**REPORT of  
DIRECTOR OF PLANNING AND REGULATORY SERVICES**

**to  
SOUTH EASTERN AREA PLANNING COMMITTEE  
18 JUNE 2018**

<b>Application Number</b>	<b>HOUSE/MAL18/00562</b>
<b>Location</b>	Trusses Waterside Road, Bradwell-on-Sea
<b>Proposal</b>	Construction of a garden room, porch, cart lodge, a swimming pool and associated pool house. Erection of 1.8m high close boarded fence, timber entrance gates and posts and picket fencing.
<b>Applicant</b>	Mr and Mrs Geoff Pearce
<b>Agent</b>	Mr Anthony Cussen – Cussen Construction Consultants
<b>Target Decision Date</b>	03.07.2018
<b>Case Officer</b>	Devan Lawson, TEL: 01621875845
<b>Parish</b>	<b>BRADWELL-ON-SEA</b>
<b>Reason for Referral to the Committee / Council</b>	Member Call In Cllr. Dewick Reason: Public Interest

<b>Application Number</b>	<b>LBC/MAL/18/00563</b>
<b>Location</b>	Trusses Waterside Road, Bradwell-on-Sea
<b>Proposal</b>	Construction of a garden room, porch, cart lodge, a swimming pool and associated pool house. Erection of 1.8m high close boarded fence, timber entrance gates and posts and picket fencing.
<b>Applicant</b>	Mr and Mrs Geoff Pearce
<b>Agent</b>	Mr Anthony Cussen – Cussen Construction Consultants
<b>Targe

## Trusses - Waterside Road

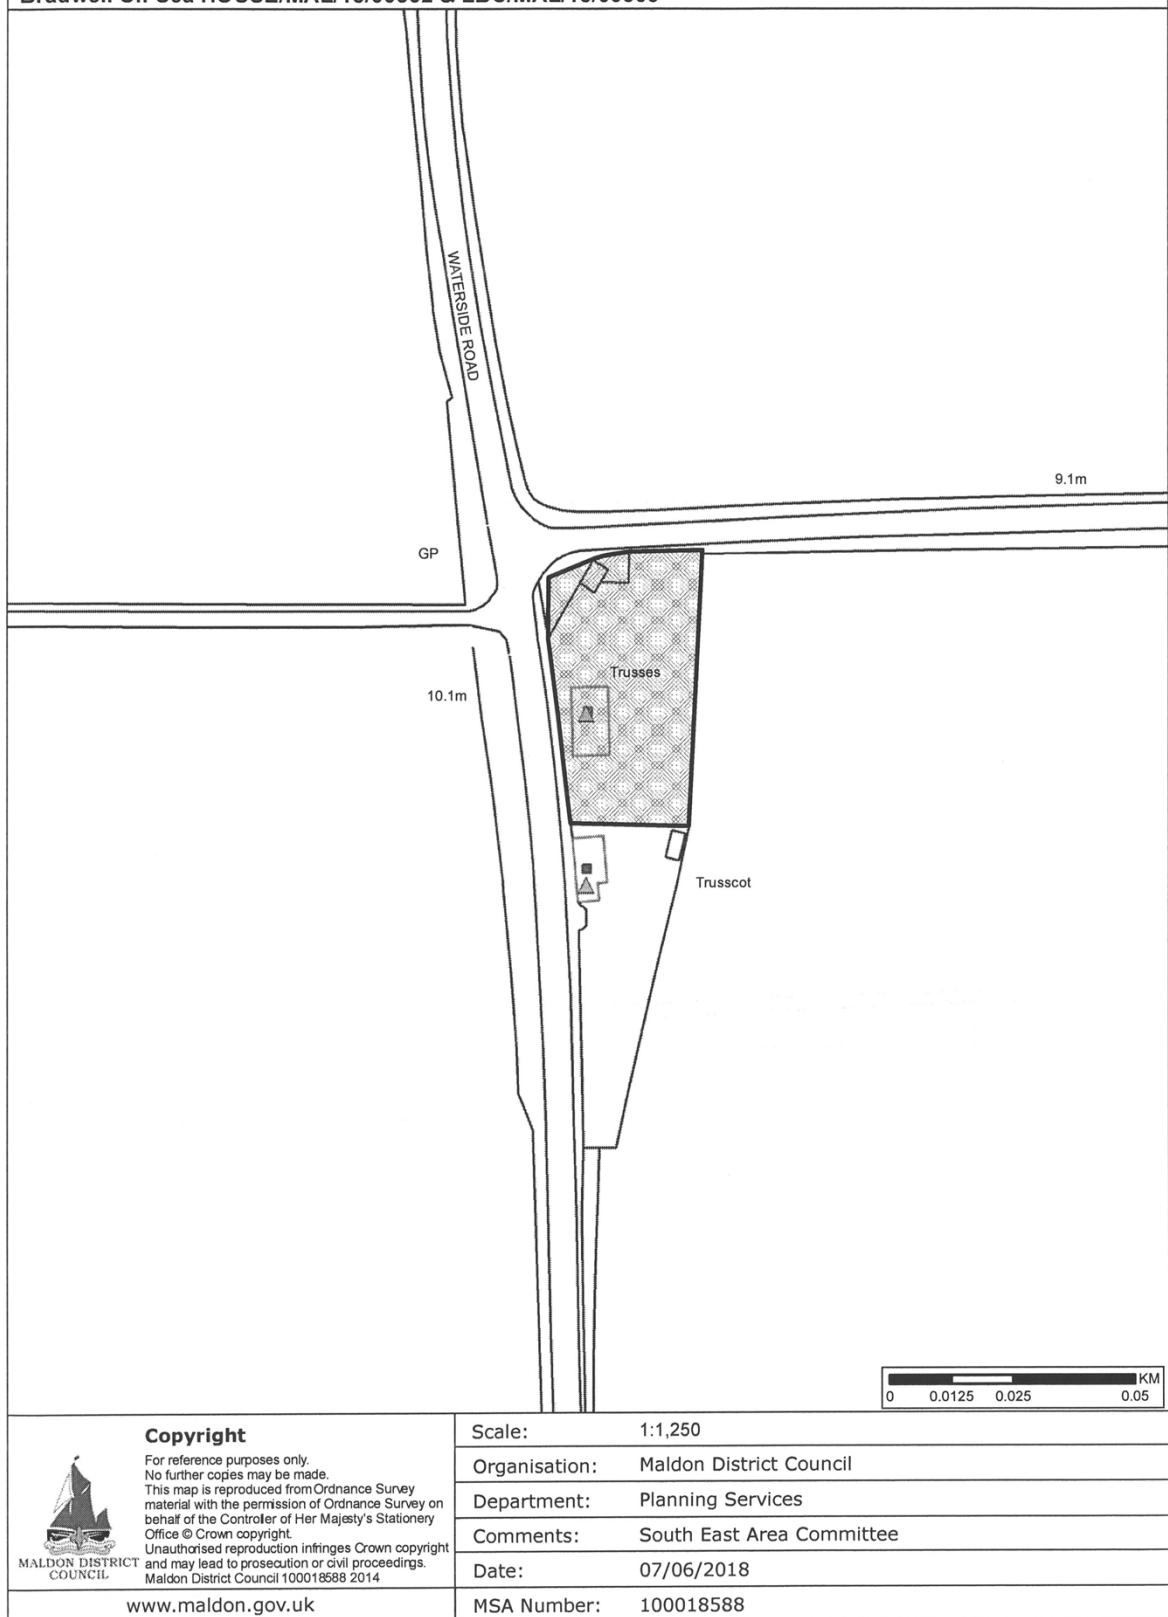
<b>Name of Internal Consultee</b>	<b>Comment</b>	<b>Officer Response</b>
Essex County Council Highway Authority (ECC)	It is noted that the red line in Drawing 1119/ 03 C is incorrectly aligned at the north- western corner of the site. The area between the western flank of the garage and junction of Trusses Road and Waterside Road is part of the publicly	The applicant has submitted a revised location plan (1119/01 A) which addresses these concerns.
